IMPROVEMENT AT MOUTH OF COLUMBIA RIVER

Mistakes of the Past and Plans for the Future Present Jetty in Wrong Direction and Leaves Discharge Channel Too Wide Proposed \$2,500,000 Extension Unwise Columbia Capable of Best Bar-Harbor Entrance in the United States.

MAP NO. 1—MOUTH OF COLUMBIA RIVER, BASED ON SURVEY OF 1901.

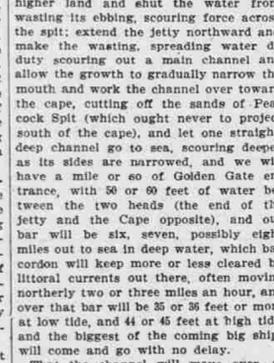
Accompanying are two maps. On the first, A-A is a recommendation of Colonel Gillespie for a pile jetty of 8000 feet, estimated cost, \$430,000, to be extended towards Cape Disappointment at will. This plan the writer in 1882 submitted to Captain James B. Eads, receiving the earnest approval of that famous engineer of Mississippi jetty fame. Colonel Gillespie's plan, however, had been referred by the Chief of Engineers to his advisory board in New York City, who condemned it, but suggested nothing in its stead, not deeming improvement of sufficient merit.

B-B is the jetty recommended by Colonel Mendell. It is a jetty extending northward about 14,000 feet, and four feet higher than the majority plan and extended as occasion required, costing, with contingencies, \$3,375,000. He said that the controlling natural feature, which seemed entitled to credit for past generations, was the occasional elevation of Clatsop Spit, and added:

C-C is the jetty as approved and built.

D-D is the proposed three miles' extension estimated to cost \$2,500,000.

While the mouth has been partially contracted advantageously, it has not been contracted enough for desired results, and if the present jetty is extended seaward, as contemplated, the extension is sure to disappoint and be abandoned. The plan has failed because it ran in the wrong direction, and also because not yet built high enough.

The jetty, as built, only comes to low water on what was a shoal sand spit, and three miles space of real depth of water is yet left. But little has been done in the way of concentration of diffused water. It has been a narrowing in looks, but not in reality.

The great flood of 1894 helped drive the bar further out, and scoured it deeper, resulting in 31 feet in the next survey of 1895, and our comparative freedom from flood since, and the consequent weakening of the force, has contributed to deterioration of depth since. During all these times the low jetty leaving a three-mile mouth has not properly concentrated any of the time, and allowed too much wastage at all times. Another 1894 flood would "extend the 40-foot channel" farther out than any proposed \$2,500,000 jetty. The flood of 1894 extended the 40-channel and bar a long way farther out than ever since. Though the entrance is not nearly so bad as in the past, the truth is it is still so wide that the channel vends and crooks, is subject to shifting sands and shoaling currents, one depth one year and another next, and bar and channel buoys have to be adjusted and readjusted to mark the changing shipway. This is all wrong, and can easily be righted, and should be without further needless delay. The river throat has been left so excessively wide that even in the last year a sand bank is cropping up like an embryo sand island over a half-mile from the cape on a line to Point Adams, right in the throat of the river, and where the ship channel came from Baker's Bay 20 years ago, and directly where the ship channel ought now to go out to sea. (See map No. 1, marked "X.")

Why not contract the too-wide mouth, where nature and sound judgment indicate, and cut out such growth as "X" shows? Let us call a halt, and be sure we are right. I feel sure we are wrong in agitating for the extension of the jetty as proposed. Let the coming river and harbor bill, as in the last one talked to death by Senator Carter, contain an appropriation for the improvement of the mouth of the Columbia, but to be expended on such plan as may be approved by the present Chief of Engineers. Colonel Gillespie has fortunately recently become Chief of Engineers. Let him be given a fair chance again at this great work, and after this lapse of 20 years, and empower him at his discretion to appoint a board of engineers to review, with all the light we now have, and let Colonel Gillespie, who for years was local engineer in charge, now say what plan of jetty extension and from what point will secure the greatest benefit.

MAP NO. 2—MOUTH OF COLUMBIA RIVER.

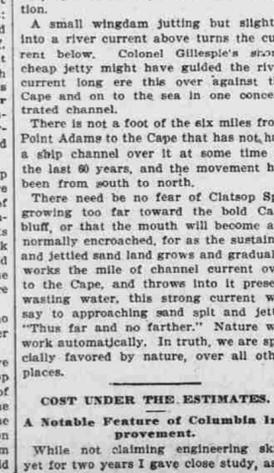
The two sand formations should never be confounded. While running into each other they are, as distinct in production and function as the heads at San Francisco or lands at each side of a mouth of a river are distinct from the sand half-moon cordon which encircles San Francisco's entrance or the entrance of any river outlet into an ocean. (See maps 2 and 3.)
